Appendix D

**GEOTECHNICAL INVESTIGATION
PROPOSED COMMERCIAL/INDUSTRIAL
DEVELOPMENT**

North Side of Napa Street East of
Etiwanda Avenue
Rancho Cucamonga, California
for
Hillwood

Subject: **Response to Second Third-Party Geotechnical Review**
Proposed Commercial/Industrial Development
North Side of Napa Street, East of Etiwanda Avenue
Rancho Cucamonga, California

BORING LOCATION PLAN	
PROPOSED COMMERCIAL/INDUSTRIAL DEVELOPMENT	
RANCHO CUCAMONGA, CALIFORNIA	
SCALE: 1" = 180'	
DRAWN: JAH	
CHKD: RGT	
SCG PROJECT 20G132-1	
PLATE 2	SOUTHERN CALIFORNIA GEOTECHNICAL

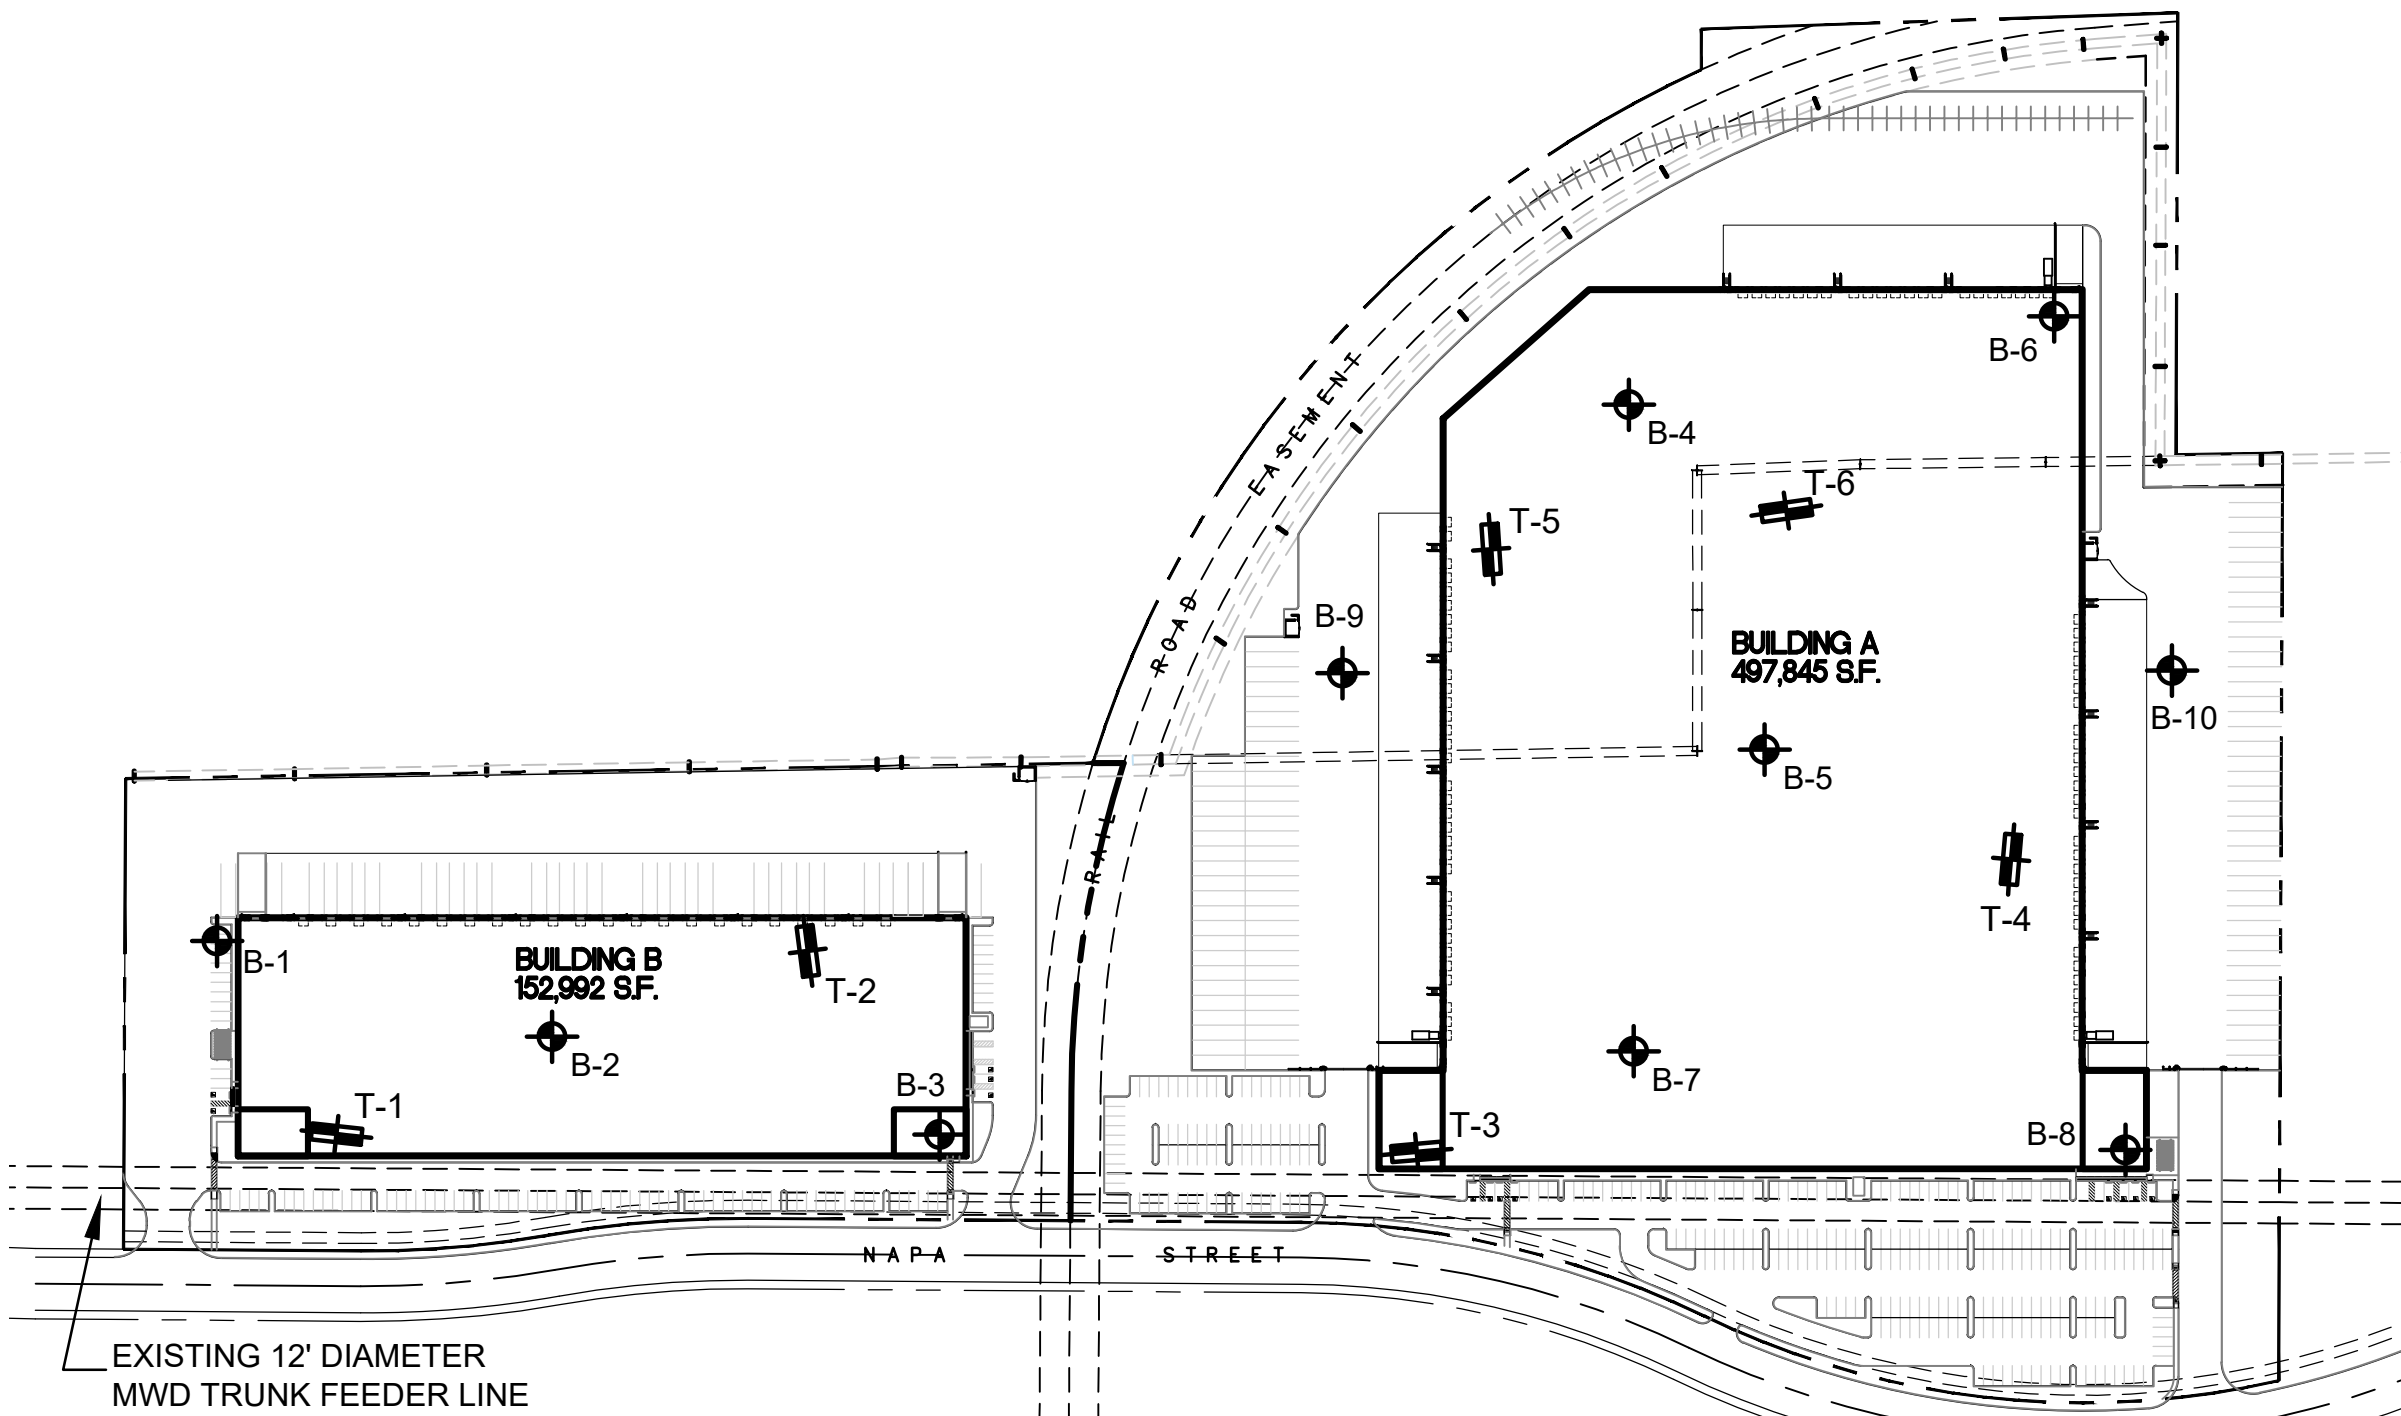
APPENDICES					
24	Appendix A	NA, Plate 2	The map provided indicates that parking and drive areas will be constructed over the existing 12 foot diameter water line. Previous report statements indicate the water line should not be surcharged. Construction and materials used for construction of the parking and drive areas as well as design grades may surcharge this line on a temporary or permanent basis. The consultant should address this issue and provide comment/recommendations within the report.	The depth of the existing water line is not available. We will provide recommendations regarding the potential surcharge that will be exerted on the water line after this information becomes available and during the final grading plan review process.	The consultant has provided additional recommendation and response deferring this evaluation to a grading plan review which should also include information regarding the depth of the waterline. We recommend plans be reviewed at an early stage (50% or 75%, etc.) to allow necessary recommendations to be incorporated into structural design prior to the final document stage. It is recommended that the consultants review and provide signed and stamped concurrence with grading and foundation plans to validate the design in light of their recommendations. These review recommendations and responses should be incorporated into the project design documents and distributed to the project design team such that they are aware of the deferral. At that time, 3rd Party review of the situation may be warranted due to the sensitive nature of loading the waterline. Design documents should make contractors aware of the existence and any precaution needed to avoid stressing the waterline.

ES 24: *The consultant has provided additional recommendation and response deferring this evaluation to a grading plan review which should also include information regarding the depth of the waterline. We recommend plans be reviewed at an early stage (50% or 75%, etc.) to allow necessary recommendations to be incorporated into structural design prior to the final document stage. It is recommended that the consultants review and provide signed and stamped concurrence with grading and foundation plans to validate the design in light of their recommendations. These review recommendations and responses should be incorporated into the project design documents and distributed to the project design team such that they are aware of the deferral. **At that time, 3rd Party review of the situation may be warranted due to the sensitive nature of loading the waterline. Design documents should make contractors aware of the existence and any precaution needed to avoid stressing the waterline.***

SCG: We agree with the reviewer. We have requested that the client provide us with the precise grading plans for building A, when they become available, as well as more complete plans for the entire site as the design progresses.

Appendices: Plate 1: Boring, Trench and Infiltration Test Location Plan
Seismic Settlement of Dry Sands – 4 Pages

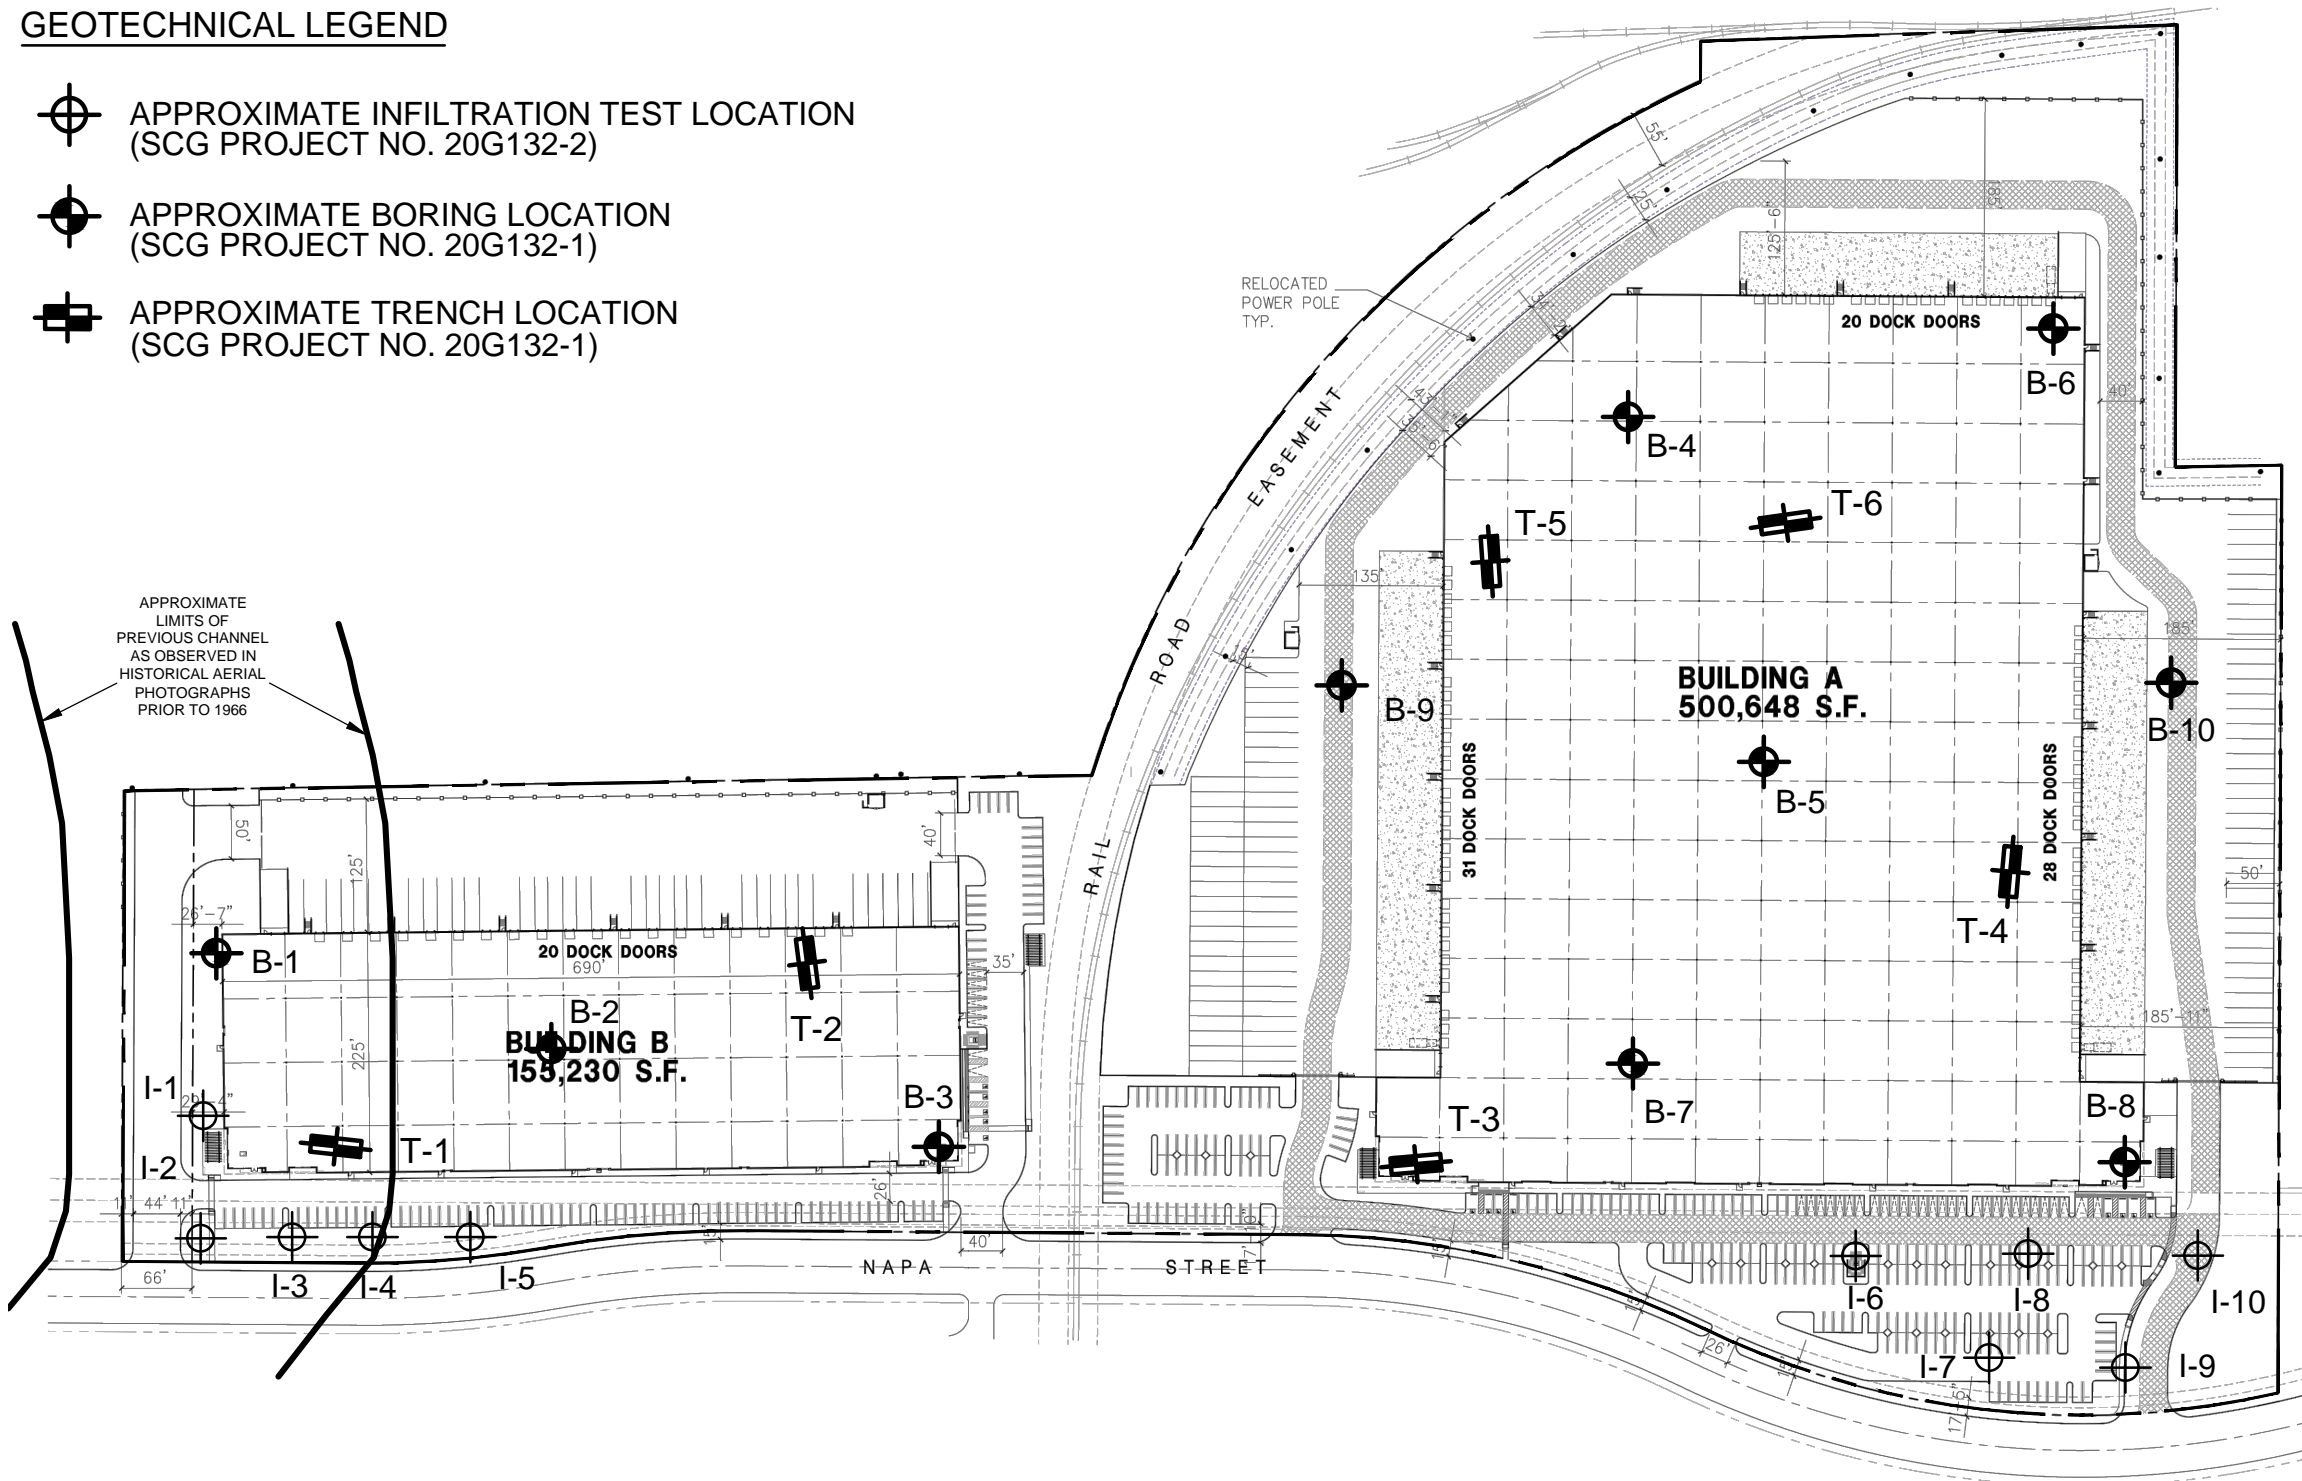
Comment No.	Section	Page	Comments	Applicant Response	2nd Review Comments (2/19/2021)	Responsibility
1	3.1	4	Cursory review of historic aerial photos shows a significant drainage area (incised channel) existing in the western area of the site in photos from 1938 to 1994. This channel would likely encompass the western approximate 1/3 of the shown Building B. No discussion of this channel is provided by consultant. The consultants should provide discussion of this channel, potential for non-homogeneous soils, and provide any additional recommendations for remedial grading if needed.	Based on our review of the historic photos, the limits of the former drainage channel extend into approximately 1/4 of Building B. We have included an exhibit in our formal response report, enclosed as Plate 1 of the report. As indicated in our geotechnical and infiltration reports, B-1, T-1 and I-2, performed within the former channel area, encountered fill soils consisting of silty sands, extending to a depth of up to 4 feet bgs. The underlying native soils consist of sands and silty sands, which are very similar to some of the native alluvial soils encountered at the remaining boring and trench locations. The recommended remedial grading will remove the existing fill soils, as well as a portion of the near-surface alluvium and replace these materials as structural fill. Based on our review of the historic photos and the conditions at the boring locations in the area of the former channel, we do not consider any changes to the remedial grading recommendations to be necessary.	The consultant has provided additional review and response that addresses the comment. The response appears reasonable.

SCG: Based on our review of the historic photos, the limits of the former drainage channel extend approximately into the west 1/4 of Building B. We have included an exhibit in our formal response report, enclosed as Plate 1 of the report. As indicated in our geotechnical and infiltration reports, B-1, T-1 and I-2, performed within the former channel area, encountered fill soils consisting of silty sands, extending to a depth of up to 4± feet bgs. The underlying native soils consist of sands and silty sands, which are very similar to some of the native alluvial soils encountered at the remaining boring and
